Objections and Protests to Application PB25-0792

Stearns Weaver Miller for Penrod Bros. Inc.

THIS APPLICATION DOES **NOT COMPLY WITH THE LDRs**

Required: Maintain Existing Structure

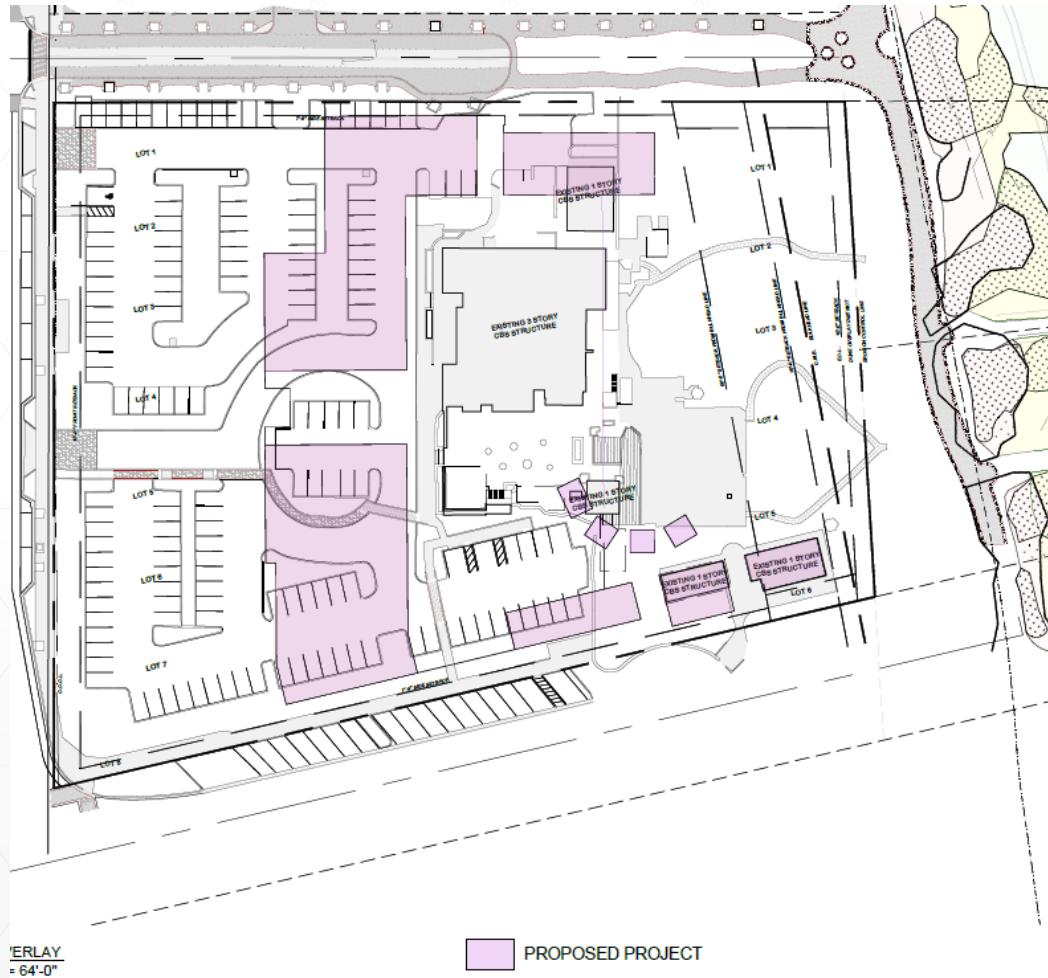
goal of having a minimum 85% waste diversion rate. Along with maintaining existing structures, we will aim to reuse and reintegrate a significant portion of the existing site materials in the project

into the design of our critical systems, landscape, and stormwater design. Our plan includes the permanence of the existing structure; however, we will be protecting the building envelope against water intrusion and damage. Additionally,

CITY EVALUATOR: So you're not proposing [] any tear-down and rebuild from scratch?

APPLICANT: Correct.

APPLICANT'S ARCHITECT: Correct. That is correct. . . what we're looking to do is we're looking to take the existing building, and, basically, we're going to rehab it.

Required: Maintain Parking Format

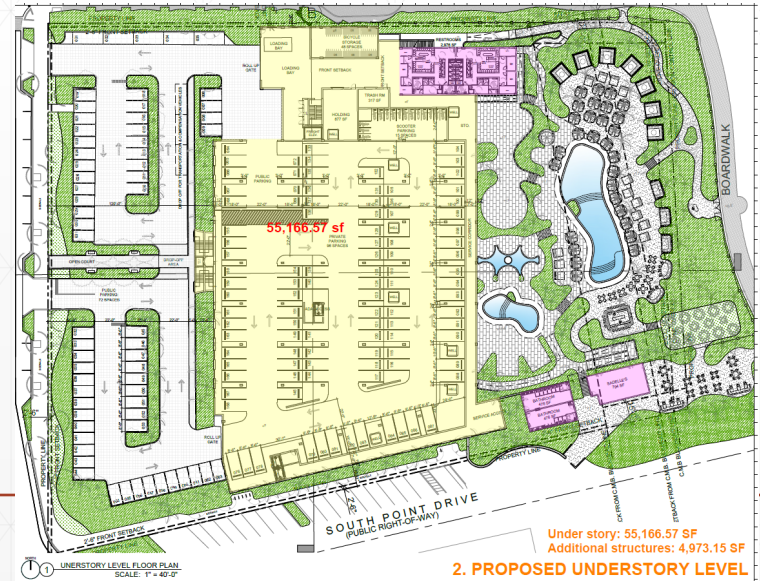
Request: New Parking Under-Story

Non-Conforming Request: New Parking Under-Story

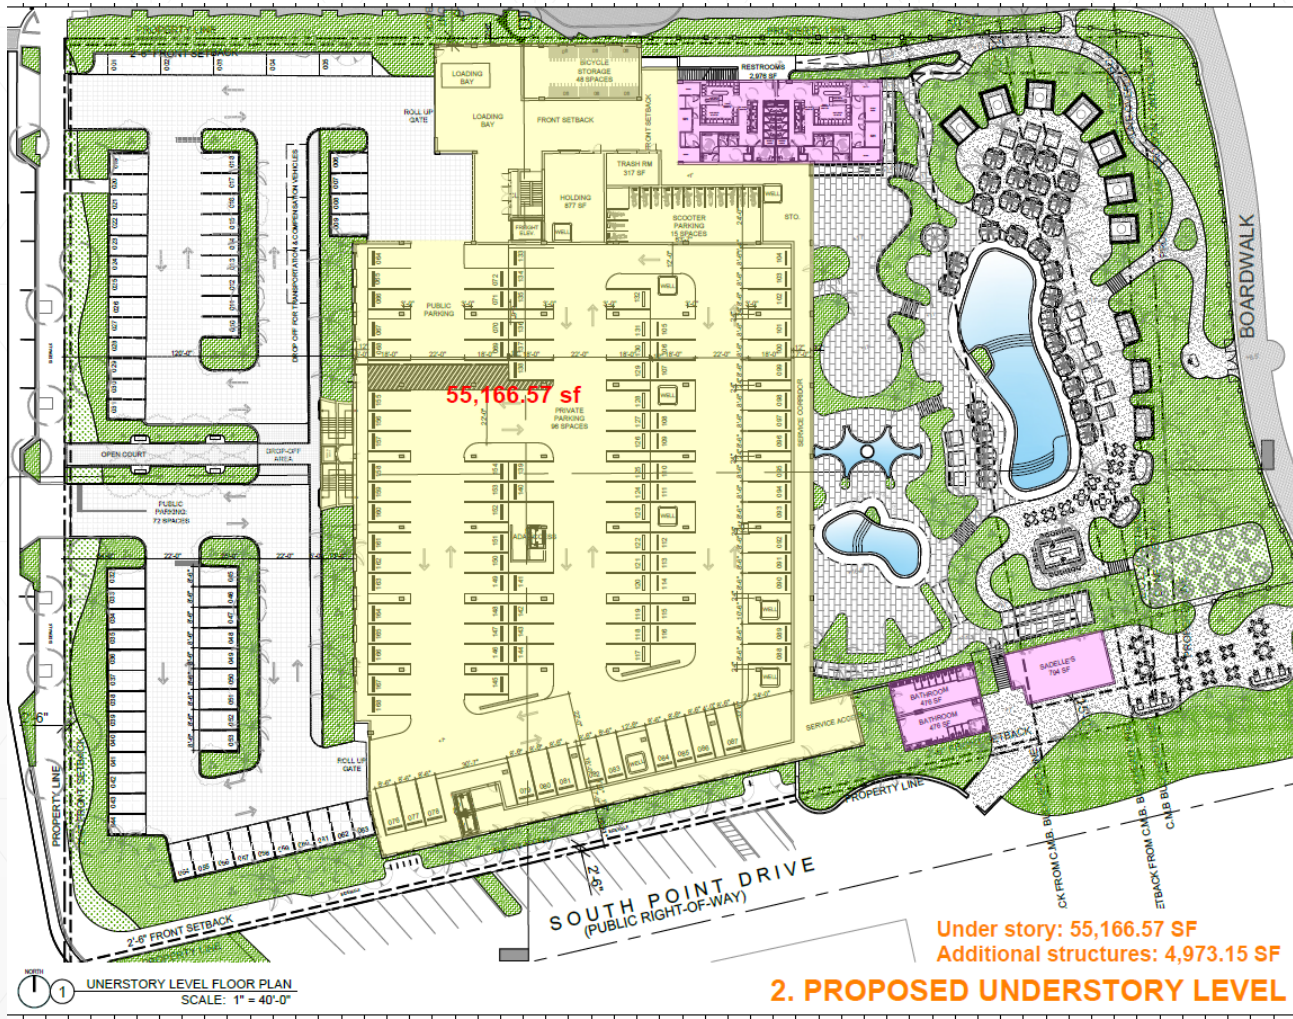
Required: Maintain Parking Format

Non-Conforming Request: New Parking Under-Story

Required: Maintain Footprint

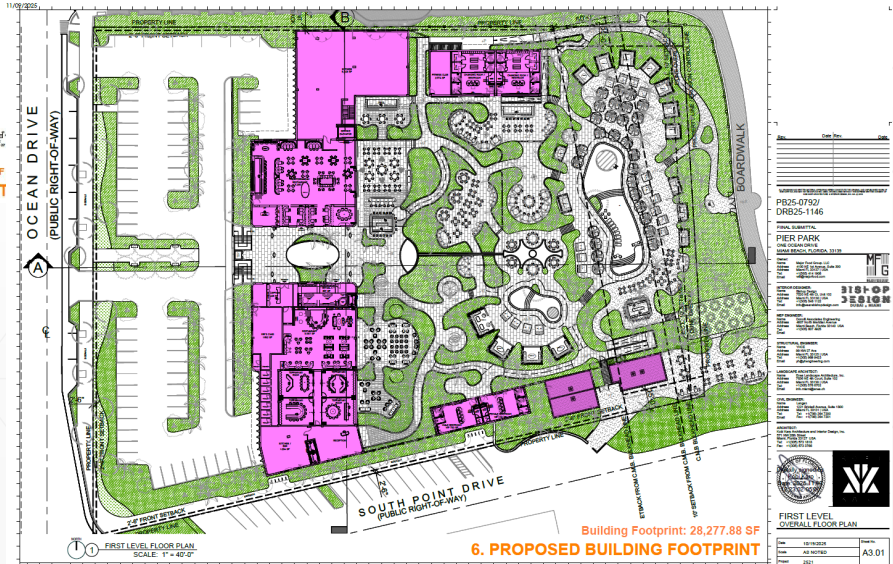
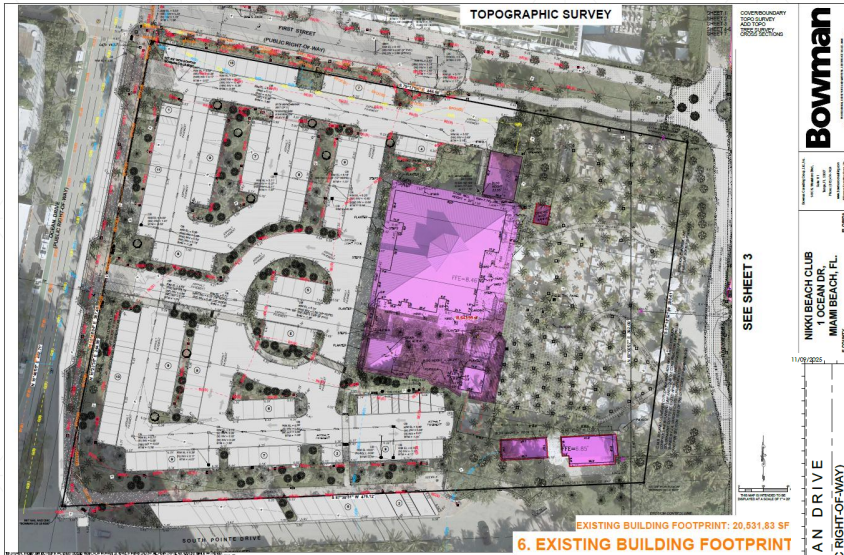
Request: Relocation & Increase Footprint

CONCEPTUAL DESIGN

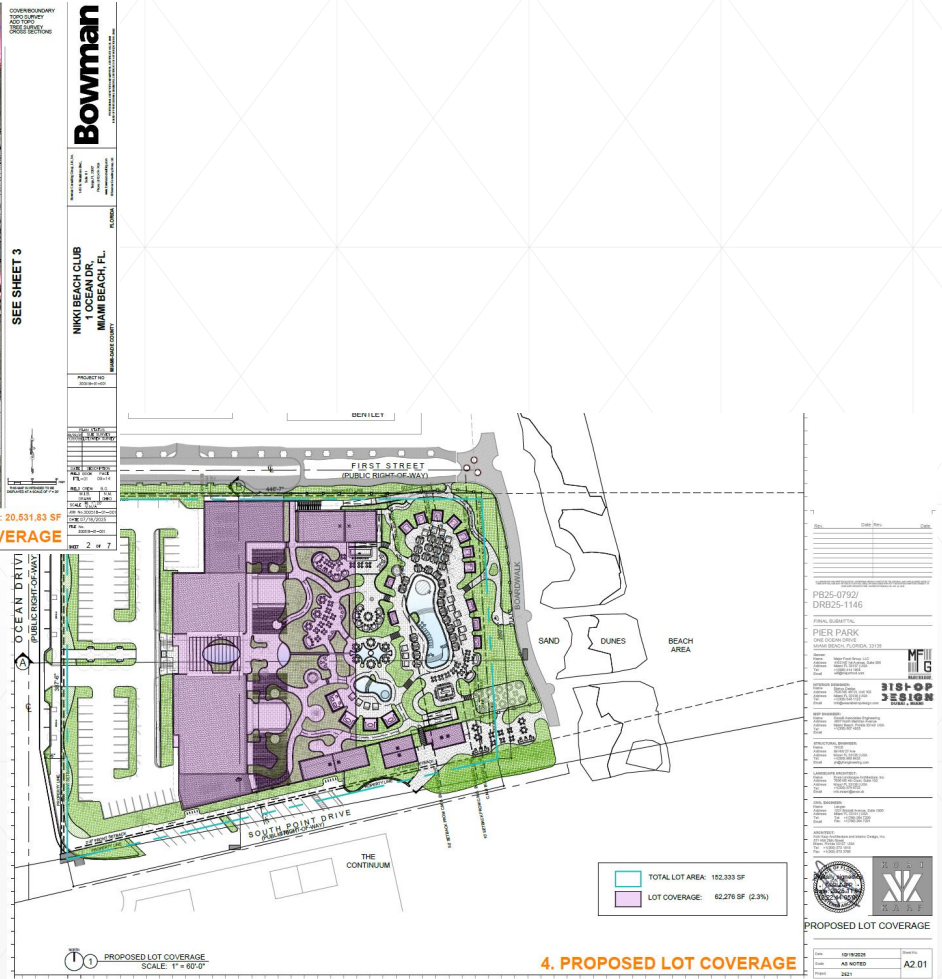
Required: FAR 23,343 SF (73,600 Max. operational)

Request: Increase Operational SF to 84,297

portion is reserved exclusively for club use. The redevelopment will maintain the existing surface level parking lot available for public use and will redevelop the site with a new 84,297 square feet beach club establishment with an expected completion date of 2028. We analyzed the three

Non-Conforming Request: Increase of Lot Coverage of 42,195 SF to 41%

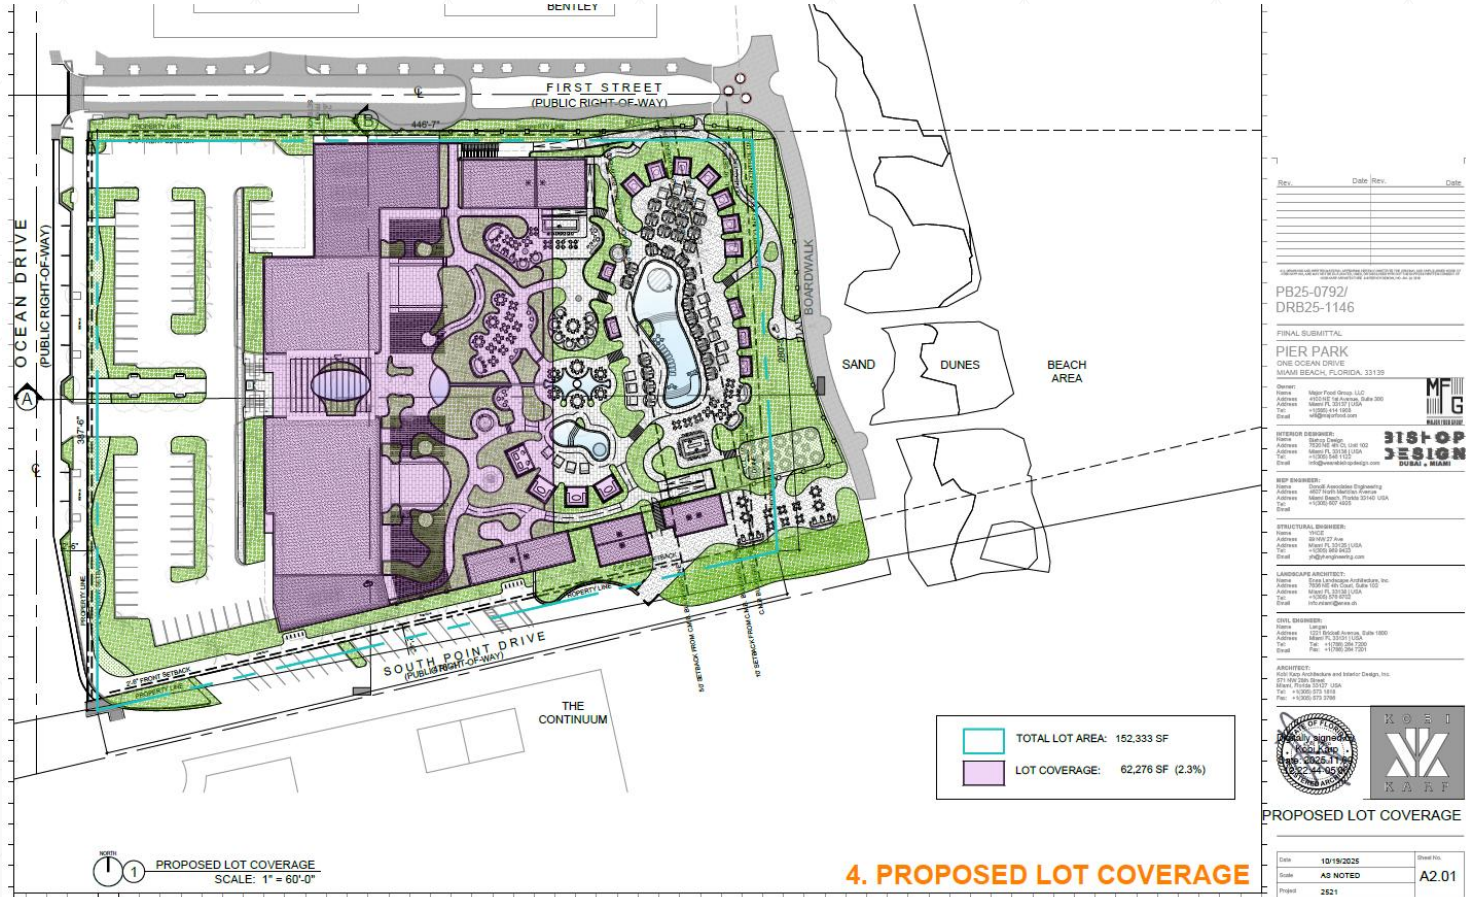
Required: Lot Coverage of 13%

Request: Increased Lot Coverage of 41%

4. EXISTING LOT COVERAGE

4. PROPOSED LOT COVERAGE

Required: Adjacent Pool & Amenities

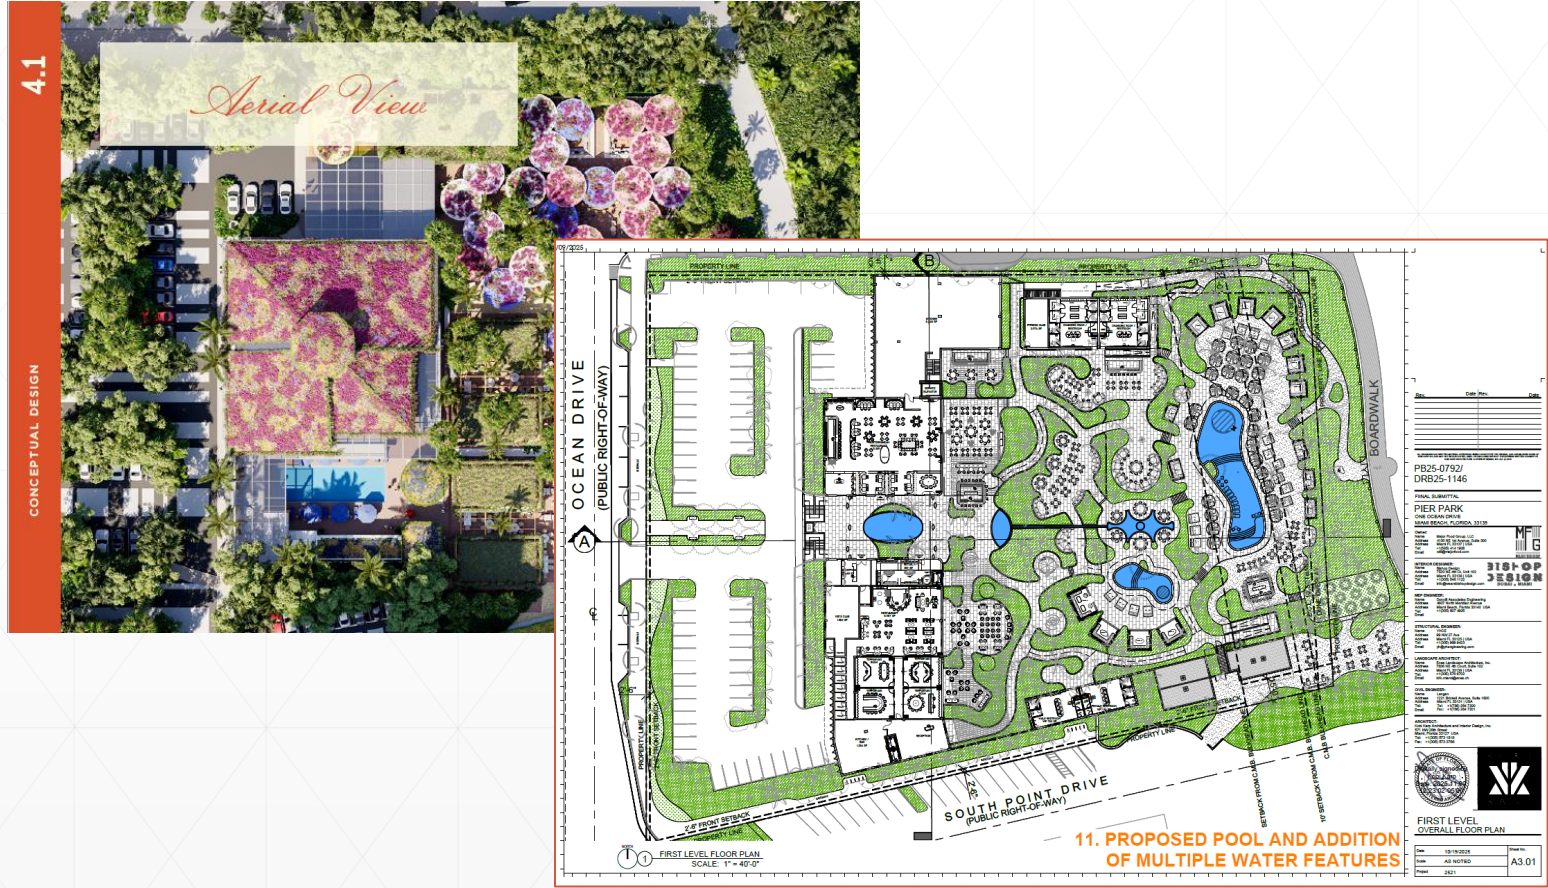
Request: Relocated Pool & Amenities

Non-Conforming Request: Relocated Pool & Amenities

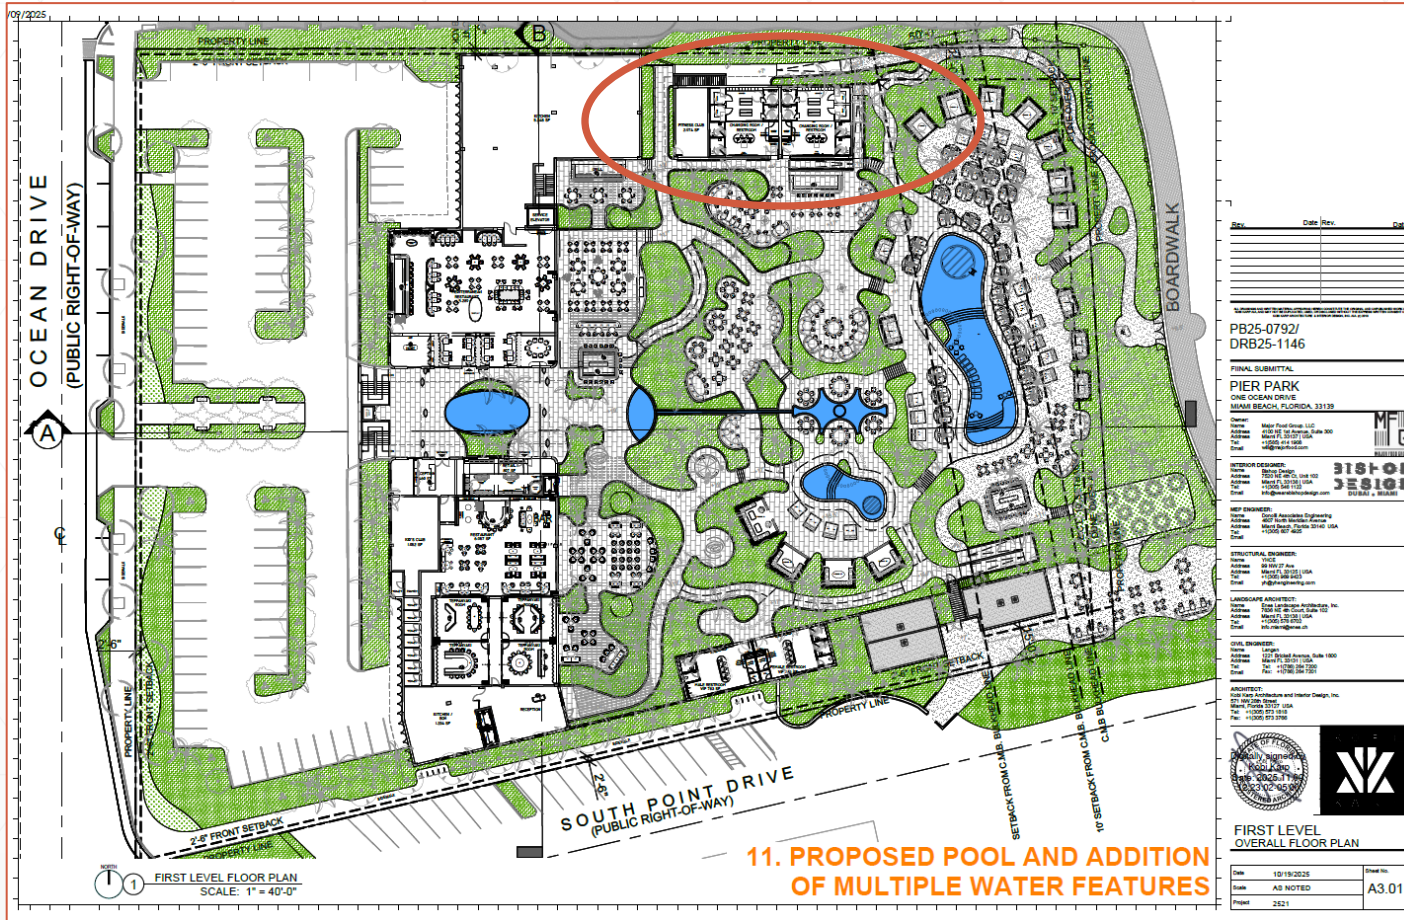
Required: Adjacent Pool & Amenities

Required: No Disruption in Parking

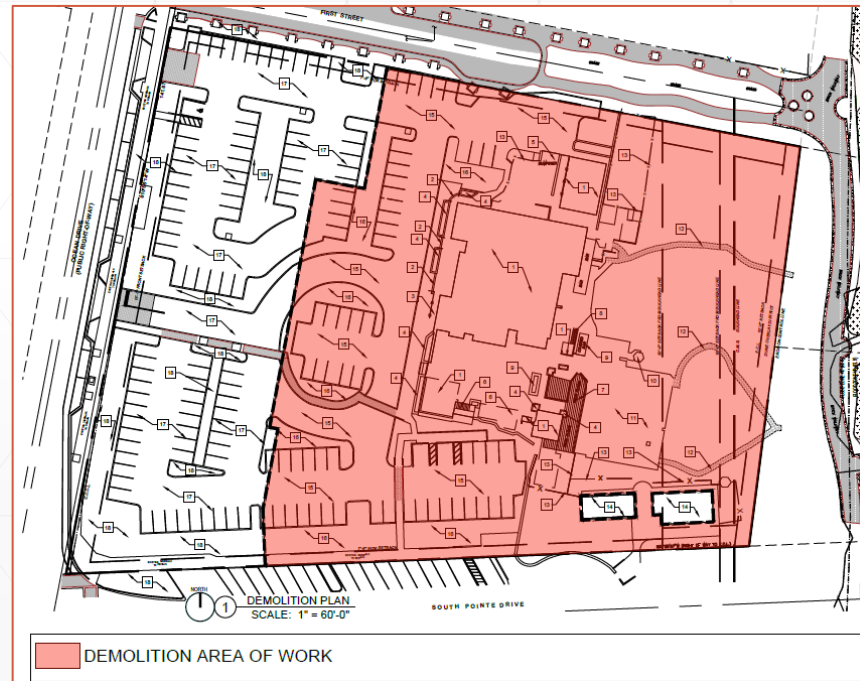
Request: Demolition and Closure of Parking

divided into two phases. At no point during the construction process will the city have less than the required 72 available parking spaces available for use.

PROJECT TIMELINE

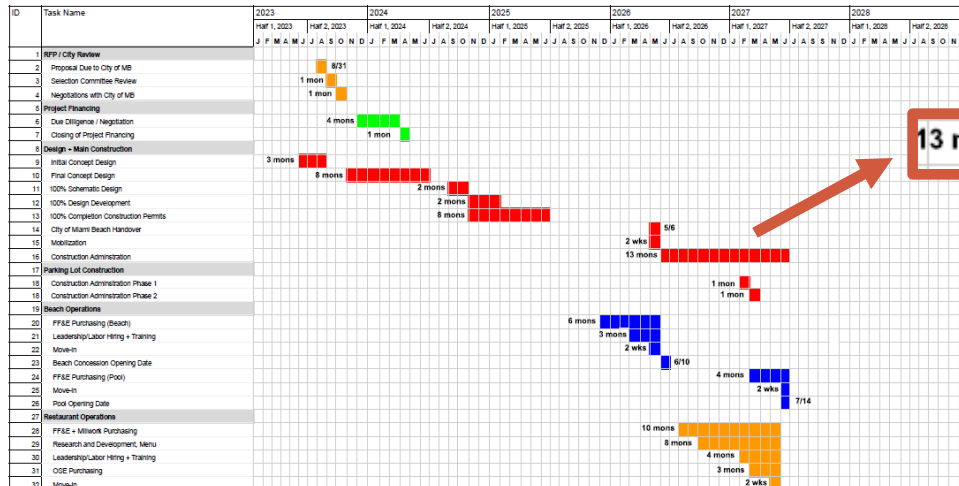
Required: 13 Month Construction Timeline

Request: 24-30 Month Construction Estimate

13 mons

The construction timeline proposed under the original submittal was 13 months, excluding design and permitting. Given the expanded scope of work in the revised proposal, the construction duration would be substantially increased.

The proposed demolition and construction of the understory will require additional time, as will soil preparation for foundations and coordination of civil infrastructure improvements. These elements represent a significant schedule impact when compared to the previous proposal, which was more limited in scope and involved less vertical construction volume.

Based on the revised scope, a conservative estimate for the construction duration would be approximately 24 to 30 months.
